MCPD
Item #1
11/8/01**MEMORANDUM**

DATE: November 2, 2001
TO: Montgomery County Planning Board
VIA: Joseph R. Davis, Chief
 Development Review Division
FROM: Wynn E. Witthans
 Planning Department Staff
 (301) 495-4584

REVIEW TYPE: Site Plan Review
APPLYING FOR: 164 multifamily units inclusive of 21 MPDU's and 18,351 square feet of commercial space
PROJECT NAME: Residences of Rosedale Park
CASE #: 8-02002
REVIEW BASIS: Sec. 59-D-3, M. C. Zoning Ordinance

CONCEPTUAL
VIGNETTES AND PLAN
DETAIL

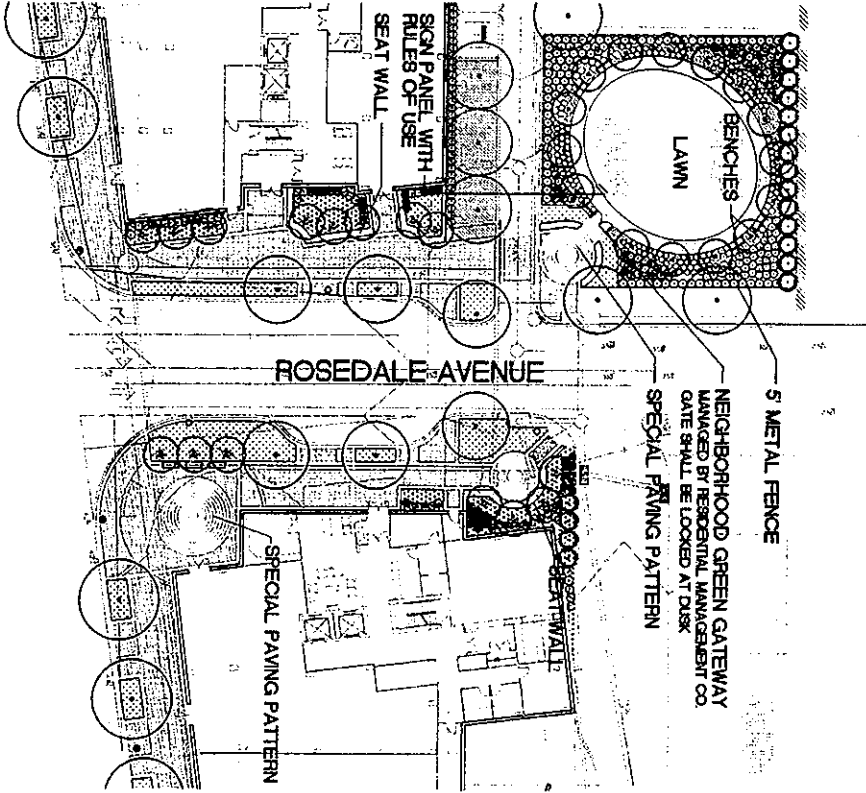
5. The proposed public artwork shown on the circular benches shall be more fully developed along the benches' vertical sides. Staff shall review any subsequent designs and shall coordinate the final submittal with the Bethesda Art Panel and other staff.

The project's art has been designed by a team of sculptors and was presented to the Bethesda CBD Art Panel. There was some concern about a few of the pieces that were shown and they were subsequently removed. The motifs the artists propose are reminiscent of the site's ecological and cultural background (plant materials, arrowheads, etc). Mosaics of these motifs will be placed in the center of the circular paving patterns and on the circular benches at the public park's entrance. Staff further recommends that the mosaics on the circular bench be further developed and the scheme brought back to the art panel.

Attachment: Site plan

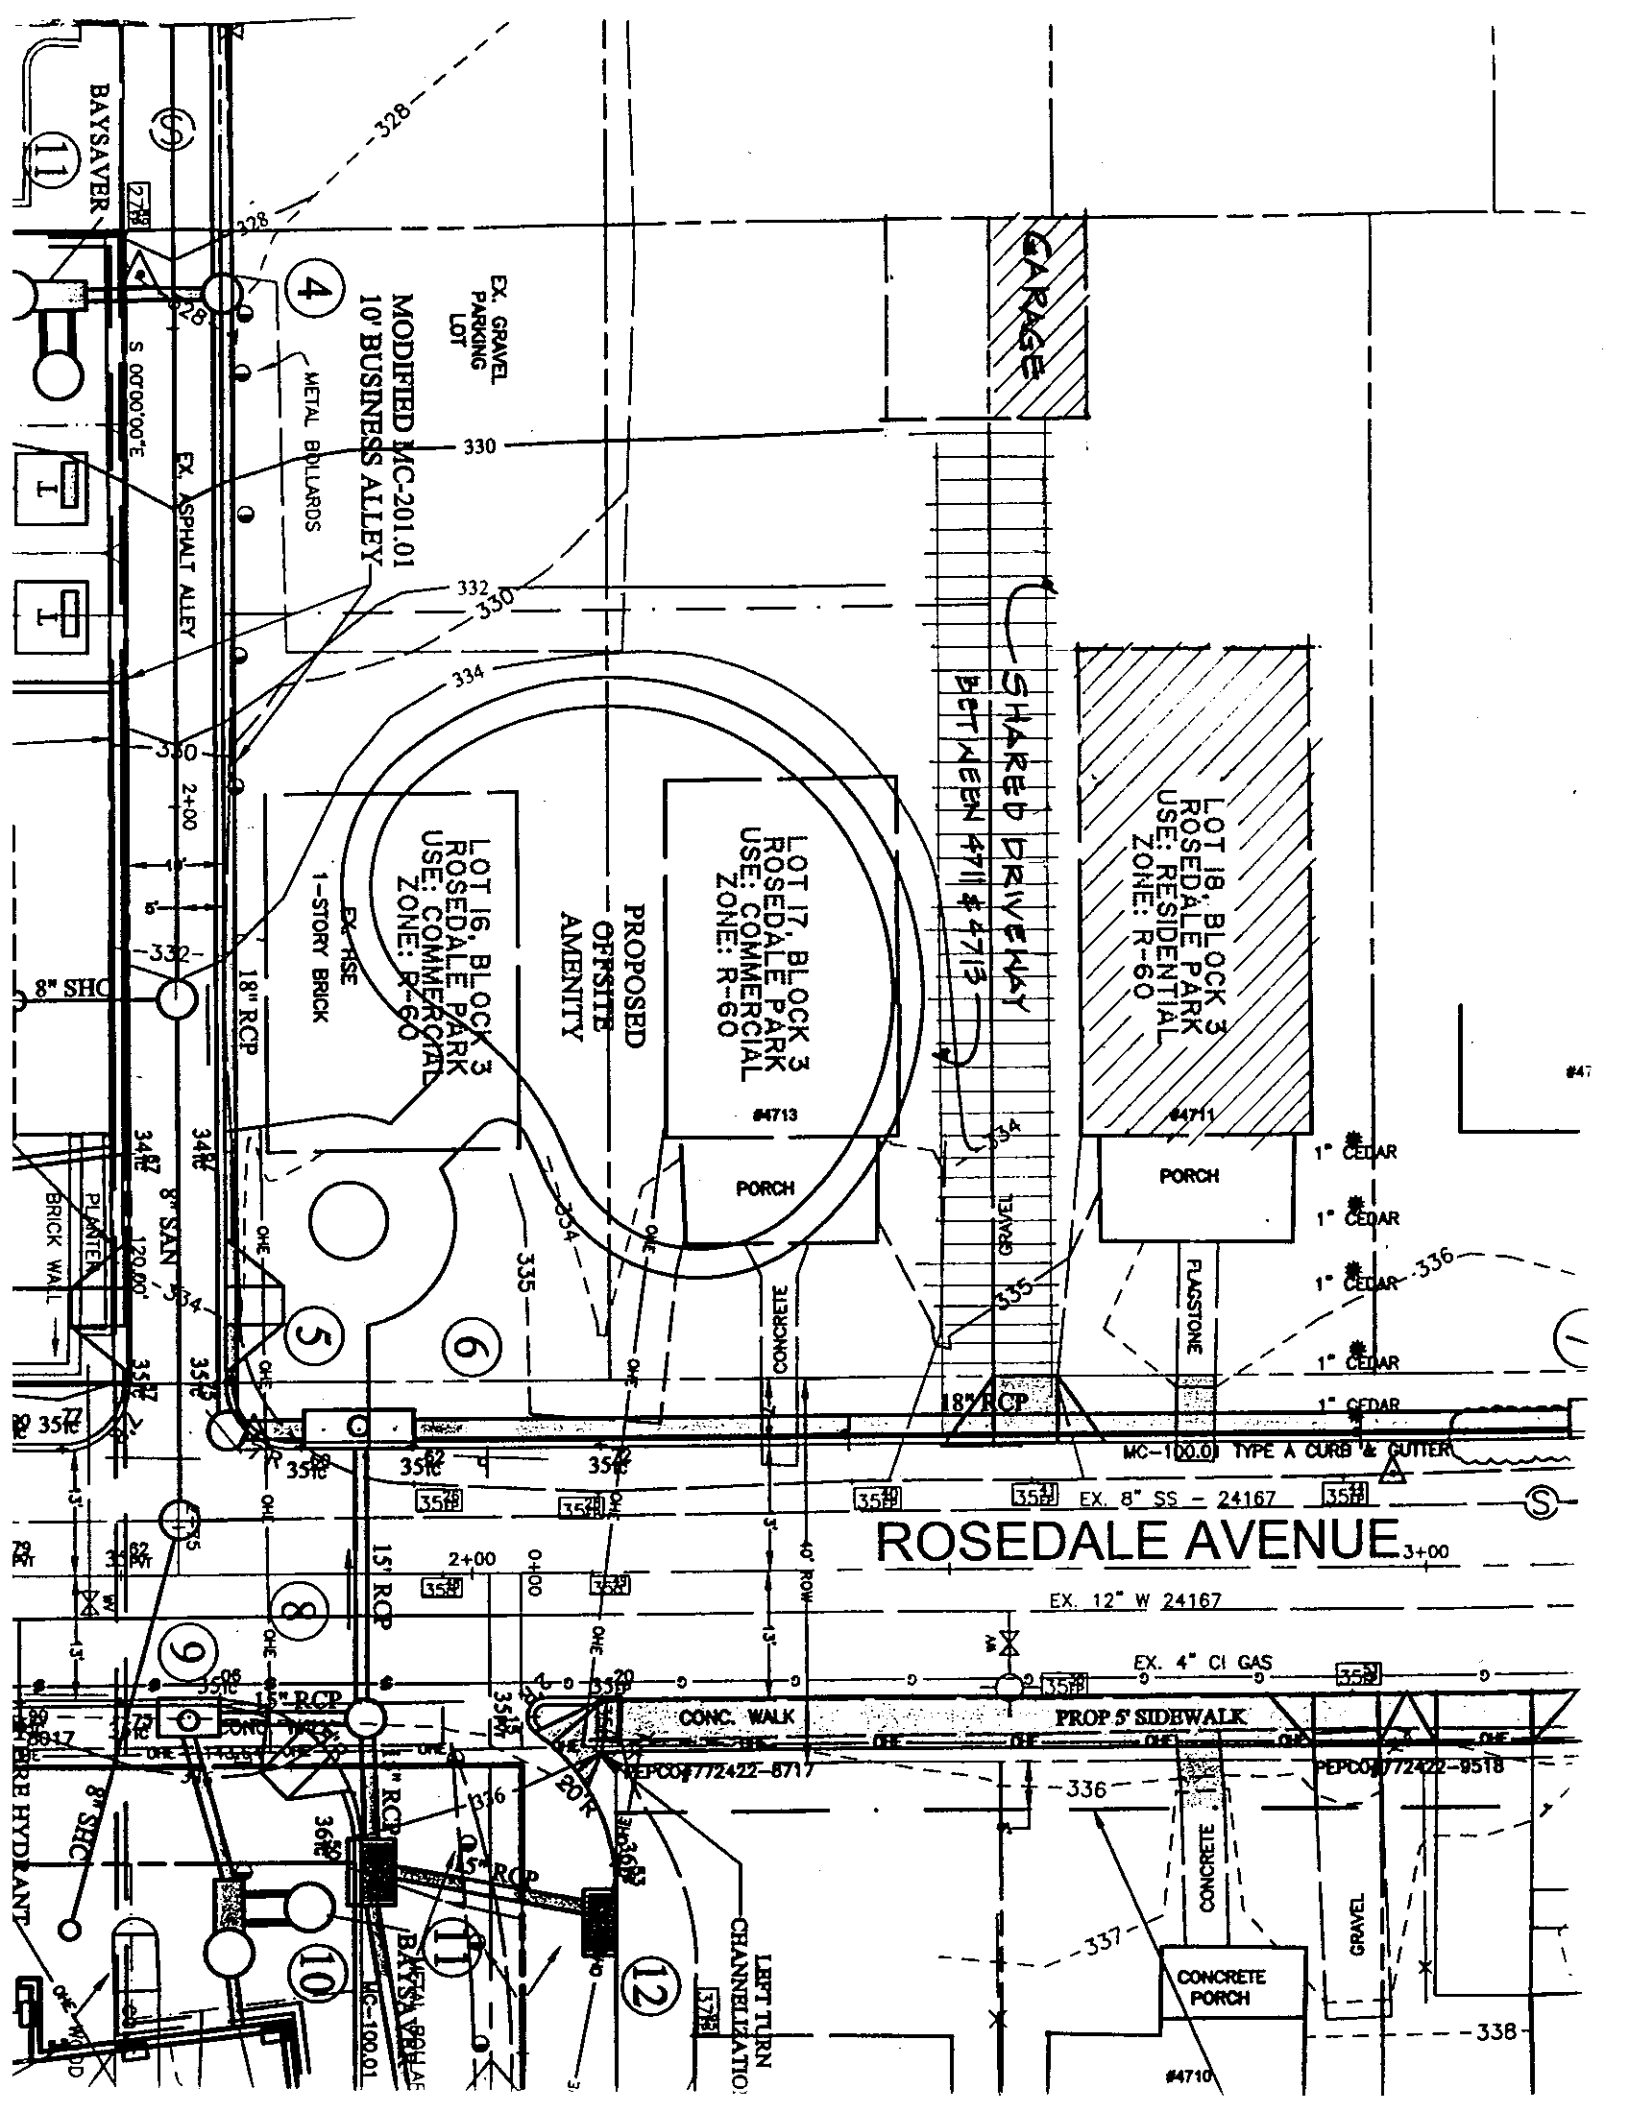
For the past 40-50 years there has been a shared driveway between my house - 4711 and 4713. (Please see the attached drawing). This is the only access to our parking at the rear. The proposed site plan presented by the Magruder team shows the east wall of the proposed park cutting right in the middle of our current driveway. This is totally unacceptable, and will make it impossible for us to use the rear parking and be able to turn around.

I have brought up this issue in the Park & Planning meeting last August, and also to the developer in few occasions, but nothing showing in the site plan has any consideration for this serious problem. Please make sure that in the site plan there is adequate space provided for a driveway and turnaround space.
